**Minor/Minor Site Review for New Detached Single Family Dwelling,
All Purpose Building Permit Application**

Location/Address of Construction: <u>7 Liberty Way, Portland Maine</u>
--

**CITY OF PORTLAND, ME
BOCA 1999 Plan Review Record
One and Two Family Dwelling**

Building Location: 7 Liberty Way CBL: 405-AGG-022

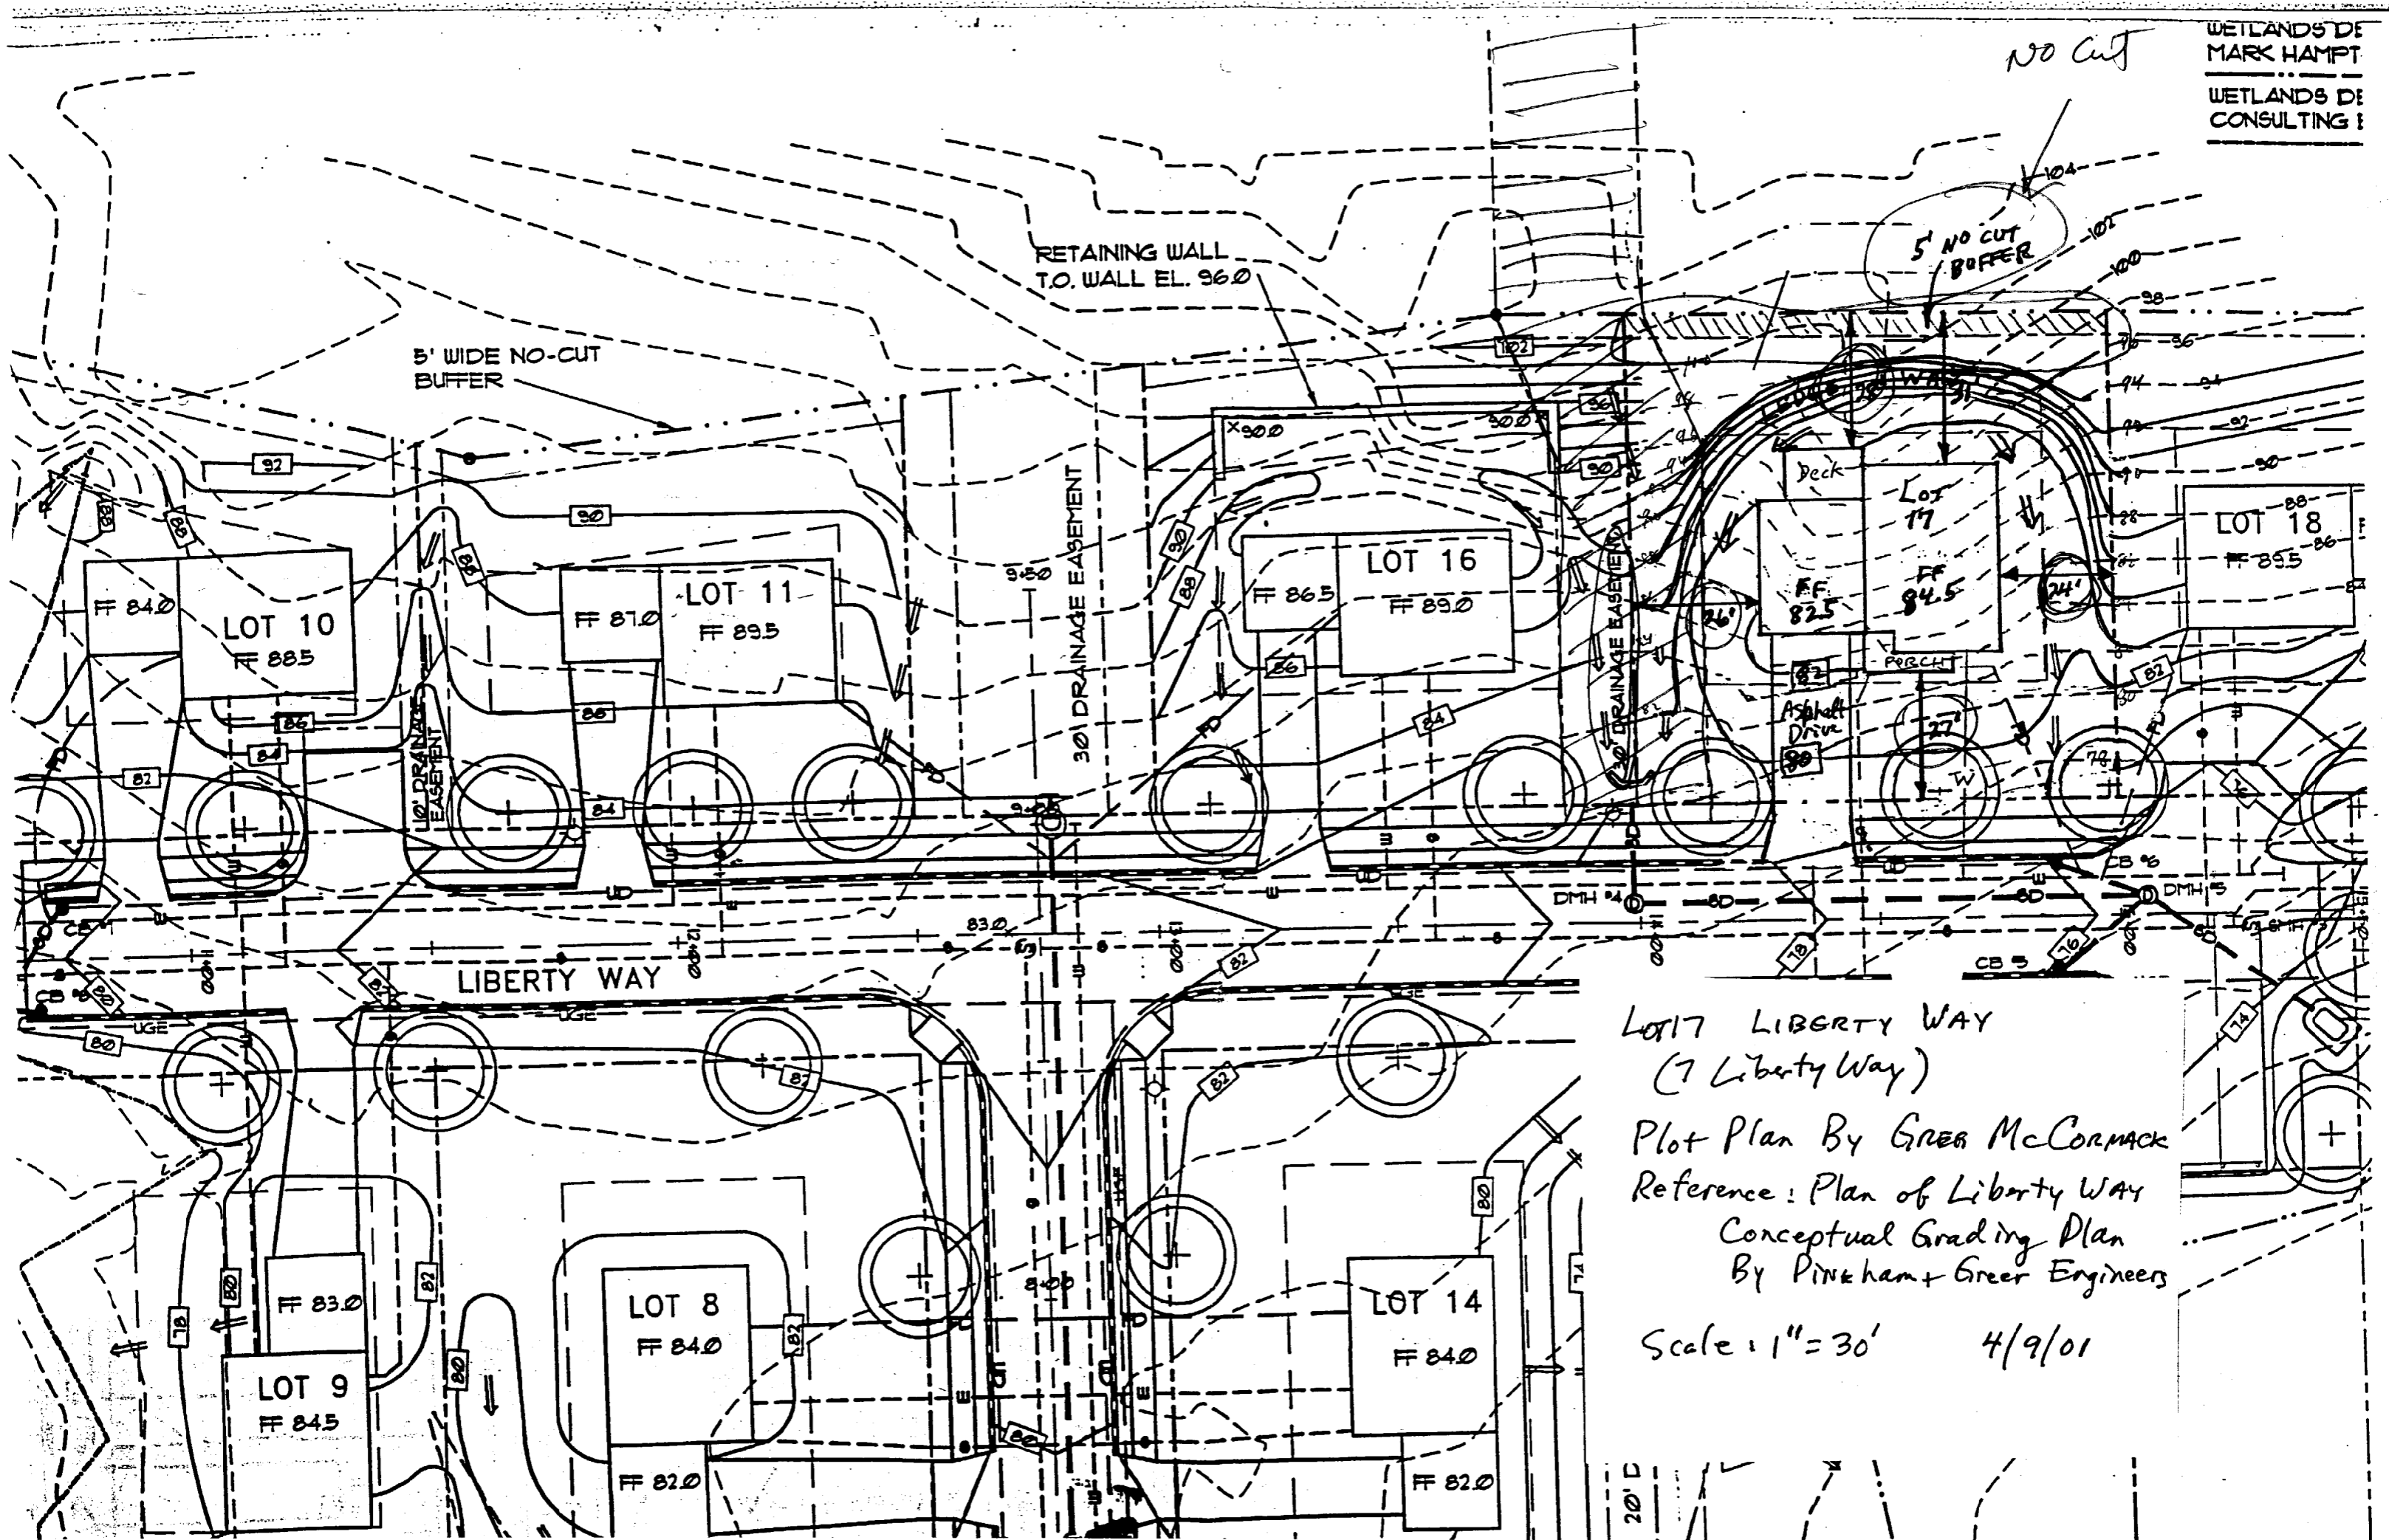
- 2 Applicant shall meet the attached standards for driveway slope.
- 3 Two (2) City of Portland approved species and size trees must be planted on your street frontage prior to issuance of a Certificate of Occupancy.

1. THE SIDEWALK WIDTH SHALL BE PAVED IN ALL CASES.
2. ALL RESIDENTIAL OR COMMERCIAL DRIVES 10% AND OVER SHALL BE PAVED.

1. THESE PROFILES ARE A GUIDE FOR THE MAJORITY OF CASES, BUT SHOULD BE FIELD CHECKED WHEN THE MAIN LINE GRADE IS STEEP (4% TO 6% OR GREATER) OR THE ANGLE OF APPROACH TO THE DRIVE IS UNUSUAL.
2. GENERALLY THE MAJORITY OF DRIVES ON A PROJECT WILL BE BUILT WITH FLATTER PROFILES THAN THESE MAXIMUM CASES.
3. WHEN GRADING DRIVES WHICH ARE FLATTER THAN THE MAXIMUM PROFILES THE FOLLOWING RULE OF THUMB SHOULD BE USED. DO NOT EXCEED A GRADE % CHANGE OF MORE THAN 9% IN A 2000 mm INCREMENT OF DRIVEWAY LENGTH. THIS APPLIES TO BOTH UP AND DOWN PROFILES.
